ORIGINATION FORM

Proposed Revisions to a Standard Plans Index
(Please provide all information — Incomplete forms will be returned)

Index Number: 700-020
Sheet Number (s): 1, 2, & 3
Index Title: MULTI-COLUMN GROUND SIGN

Index Number: 700-020
Sheet Number (s): 1 and 3
Index Title: Multi-Column Ground Sign

MULTI-COLUMN SIGN ASSEMBLY

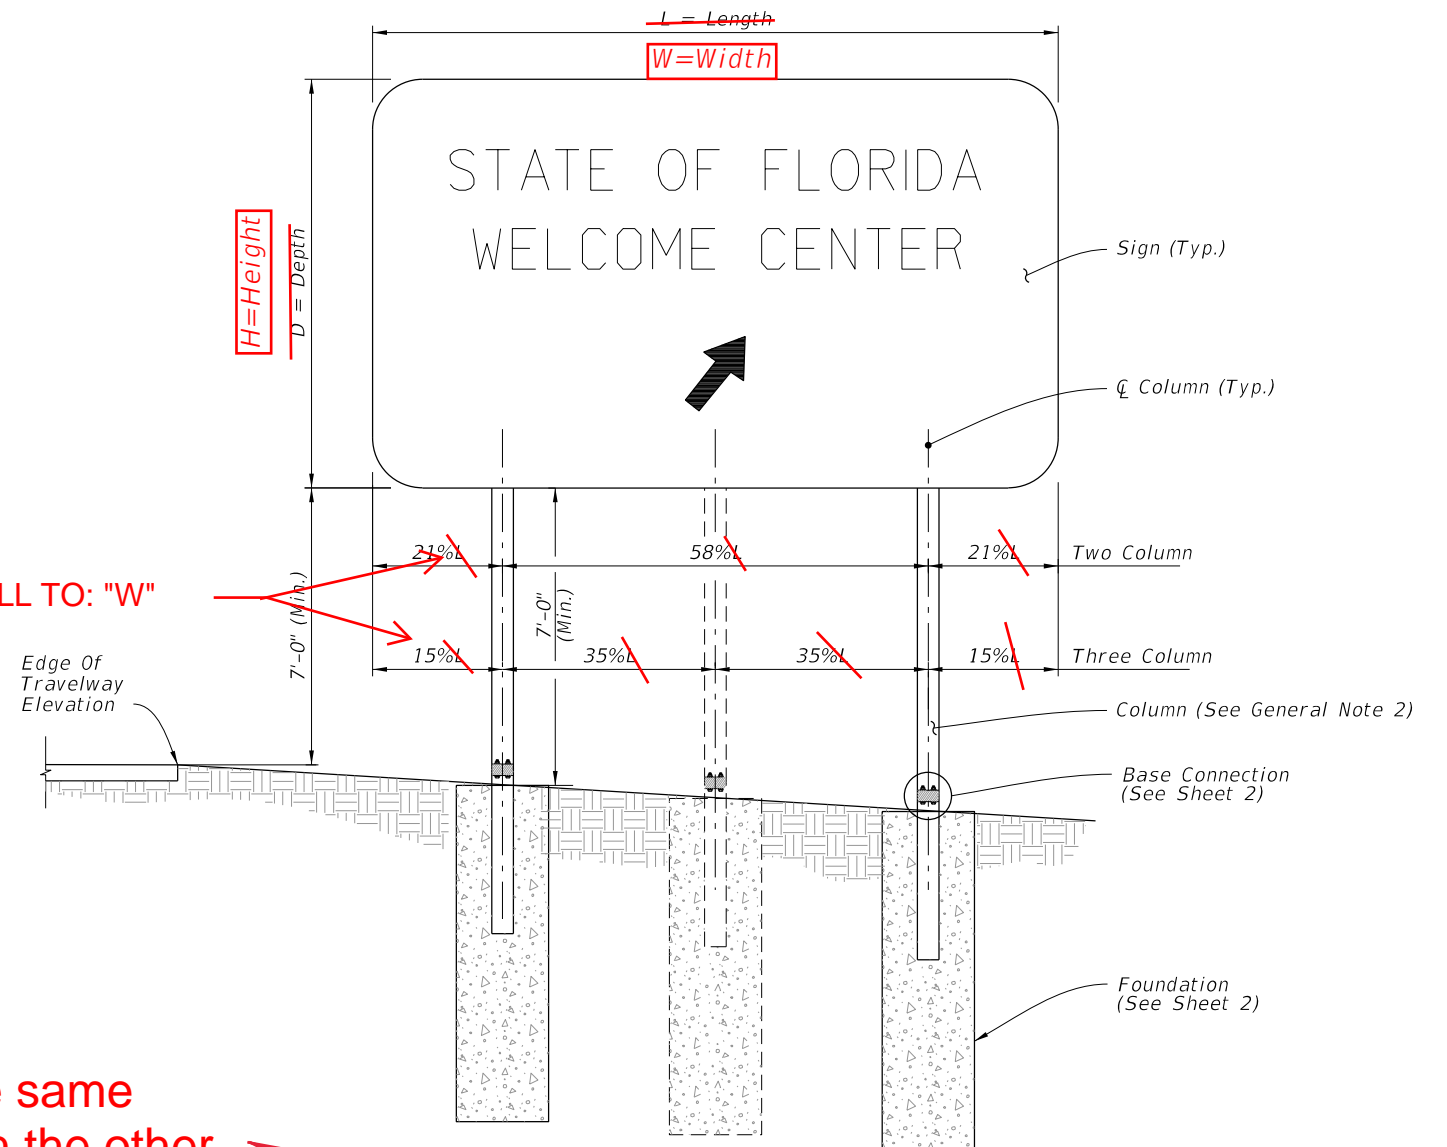
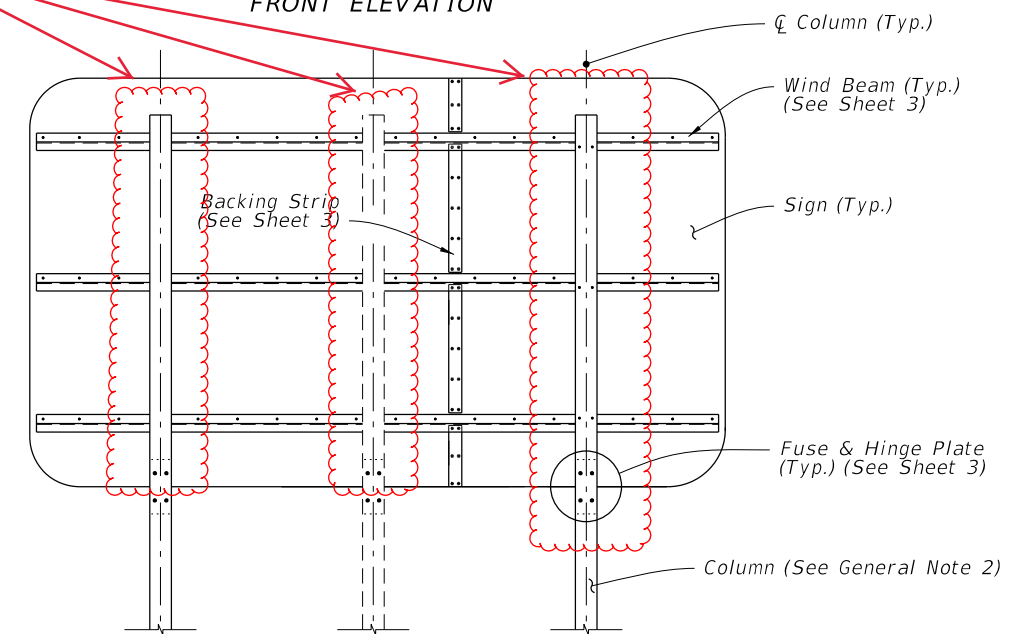
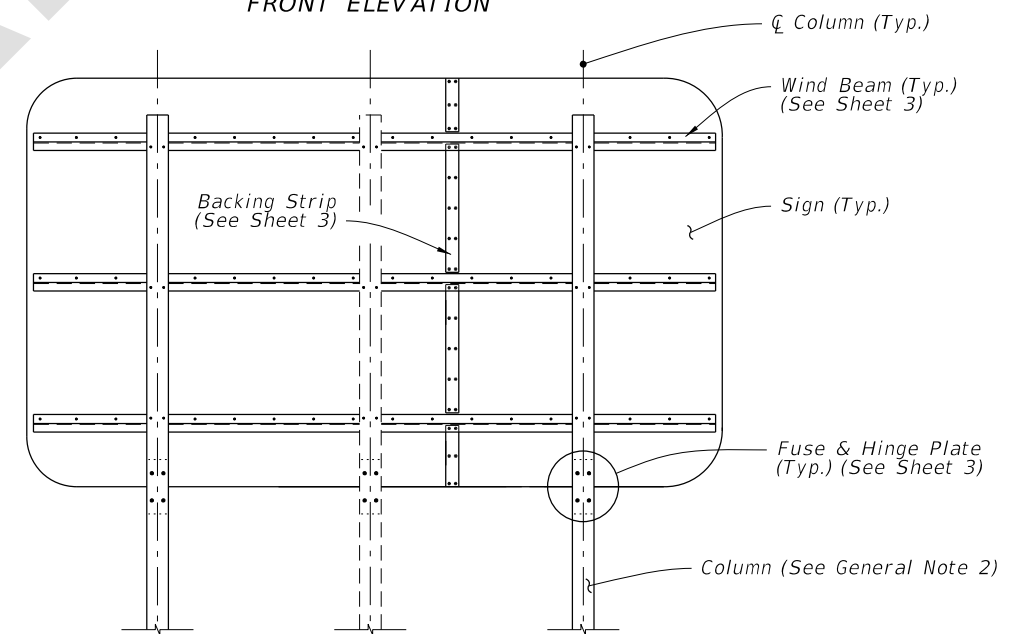
- Sheet 1: Revised bolts in the Hanger Beams to show correctly.
- Sheet 2: Added Foundation Notes to allow for precast concrete foundation with an octagon shape as a substitute for the circular shaped foundation shown.
- Sheet 3: Revised bolts in the Hanger Beams to show correctly.

- Sheets 1 & 3: The bolts were not showing correctly in the elevation details.
- Sheet 2: A non-circular, octagon shaft option was requested by industry to simplify formwork. (Revision by Richard Stepp)

On both sheets changed all reference of length to width and all reference to depth to height.

- A. Sign Support Shop drawings are not required when fabricated in accordance with this Index and support columns do not exceed the ~~length~~ ^{width} shown in the plans by more than 2'-0".
- B. Sign Panels: Horizontal panel splices are allowed at interior wind beams for sign panels with a ~~depth ("D")~~ ^{height ("H")} greater than 10 feet. Shop drawings required for horizontal panel splice details.
- C. ~~When~~ ^{Shop} drawings are required, obtain approval prior to fabrication.

CHANGE TO: height ("H")

CHANGED TO: width ("W")

CHANGED ALL TO: "W"

Show the same bolting on the other wind hanger beams

1. Meet the requirements of Specification 700.
2. Verify Column lengths in the field prior to fabrication.
3. Shop drawings:
 - A. Sign Support Shop drawings are not required when fabricated in accordance with this Index and support columns do not exceed the width ("W") shown in the plans by more than 2'-0".
 - B. Sign Panels: Horizontal panel splices are allowed at interior wind beams for sign panels with a height ("H") greater than 10 feet. Shop drawings required for horizontal panel splice details.
 - C. When shop drawings are required, obtain approval prior to fabrication.

FOUNDATION AND BASE CONNECTION DETAILS

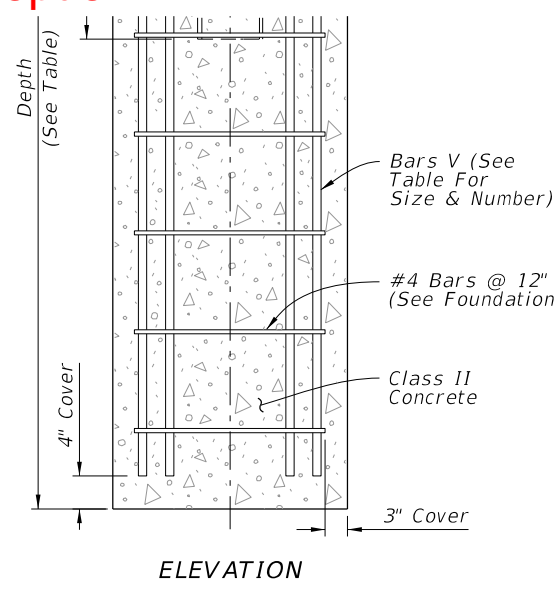
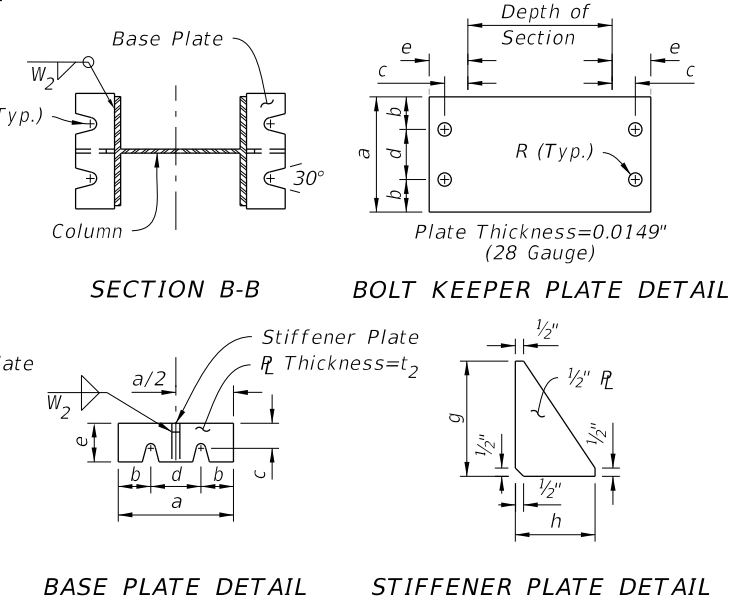
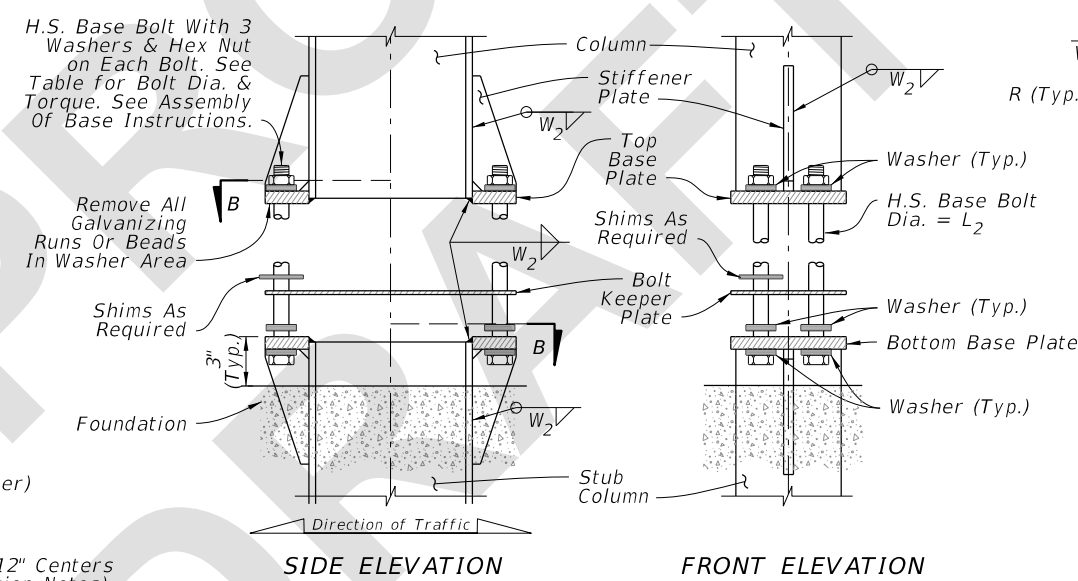
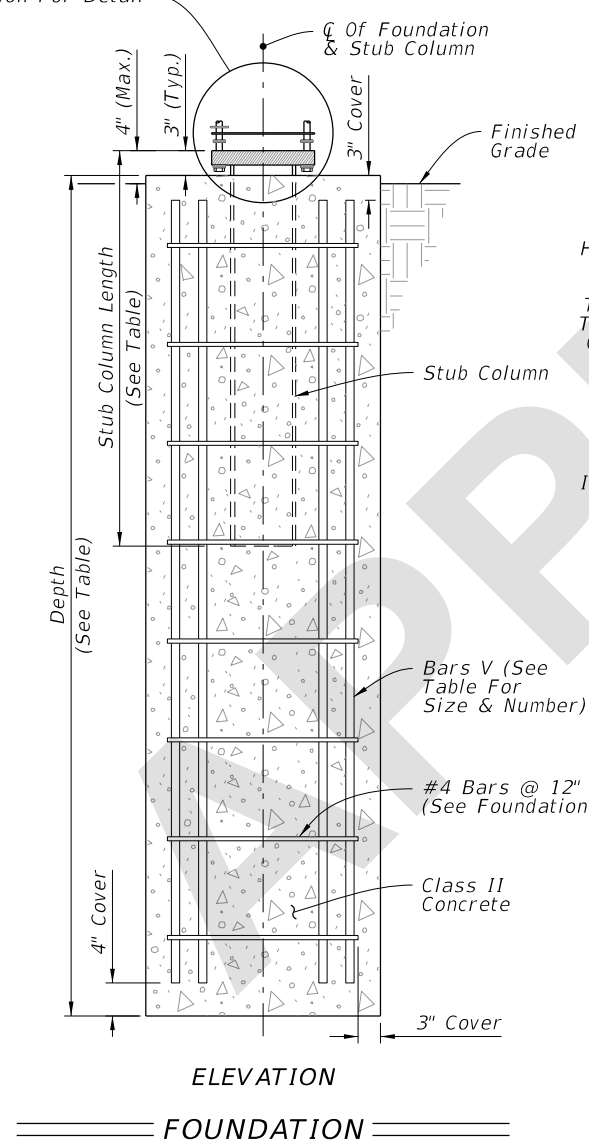
Revised note to add precast foundation option

Added note to explain the precast octagon shape option

The foundation may be either precast or cast-in-place. Use Reinforcing bars or equivalent Welded Wire Reinforcement.

For precast foundations, the circular cross section shown may be substituted with an octagon shape. The out-to-out distance between parallel edges must be greater than or equal to the diameter in the Foundation Data table. Use the same reinforcing diameter with centered placement and a minimum 3" cover.

WIND BEAM, BACKING STRIP & FUSE/HINGE PLATE DETAILS

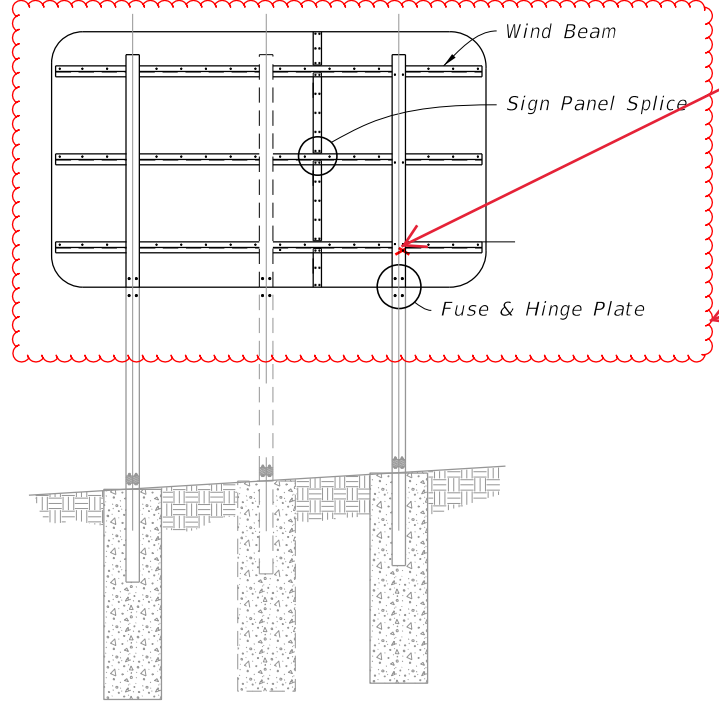
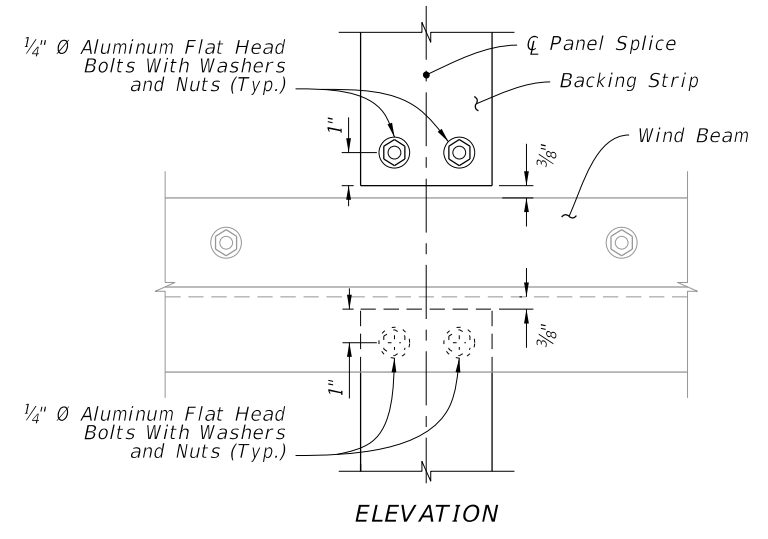
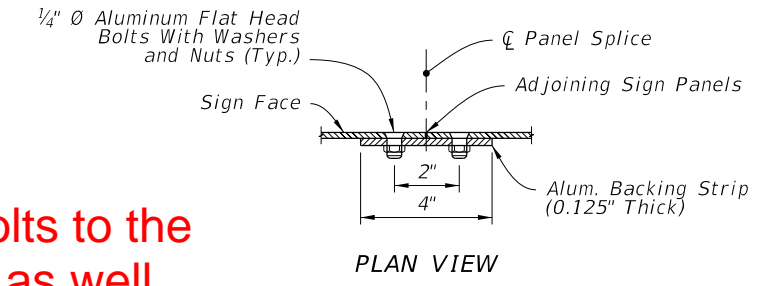
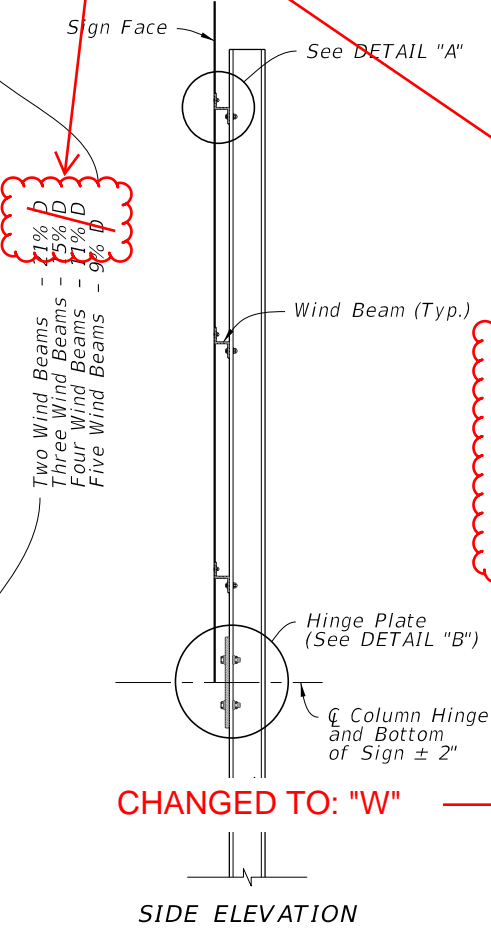
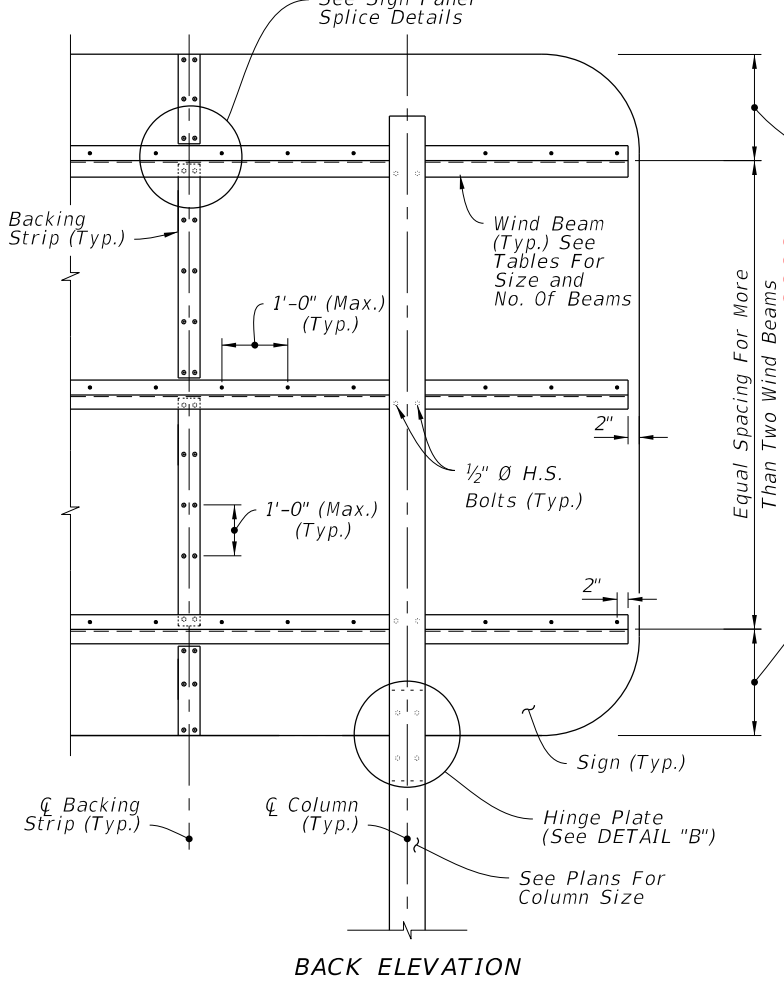
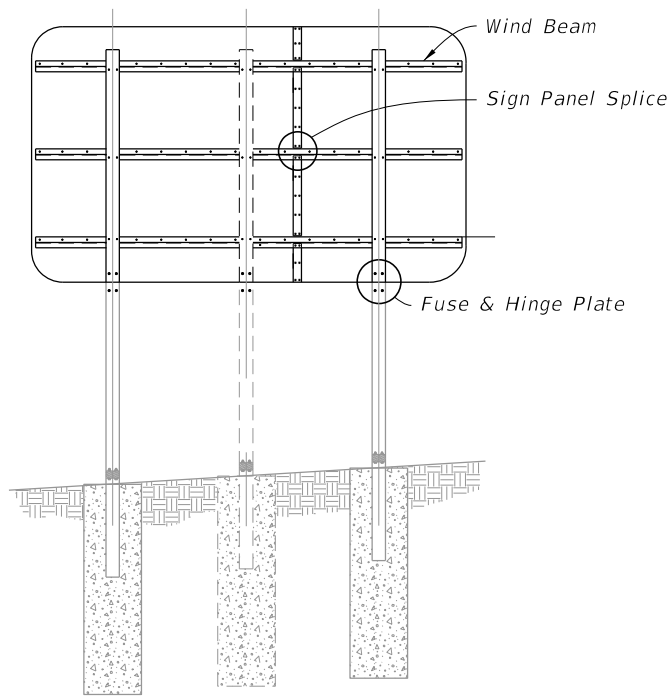
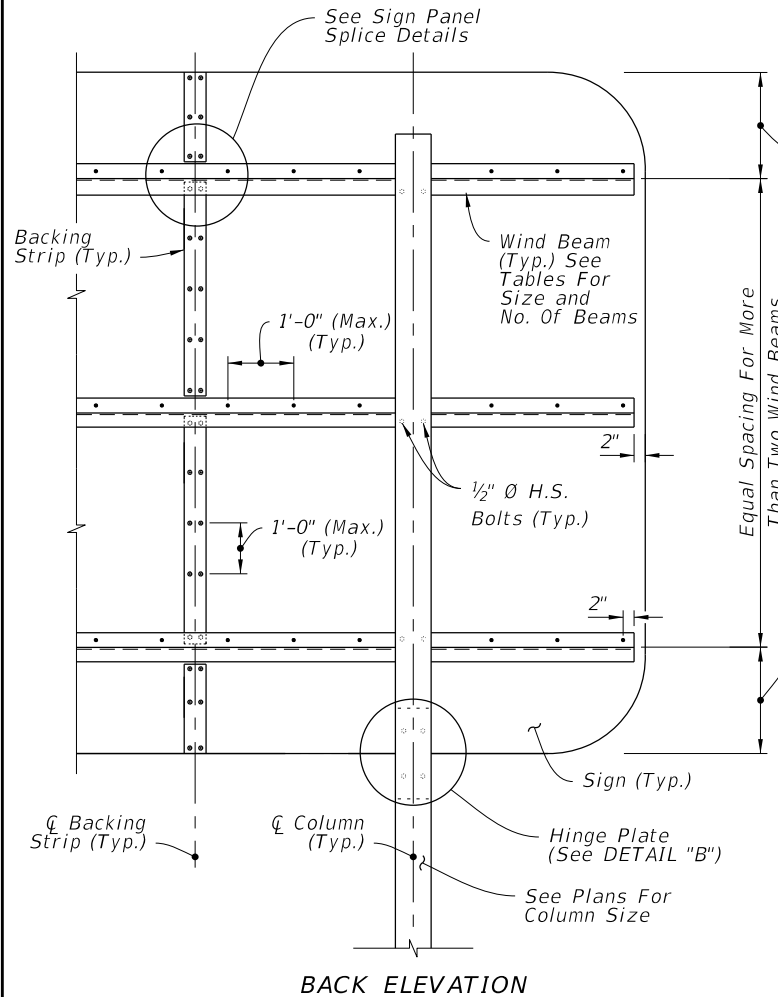
Only 2 bolts per intersection

Added the bolts to the other beams as well

BACK ELEVATION CHANGED TO: "H"

CHANGED TO: "W"

NUMBER OF WIND BEAMS BASED ON SIGN HEIGHT (H)

WIND BEAM SIZE BASED ON SIGN WIDTH (W)
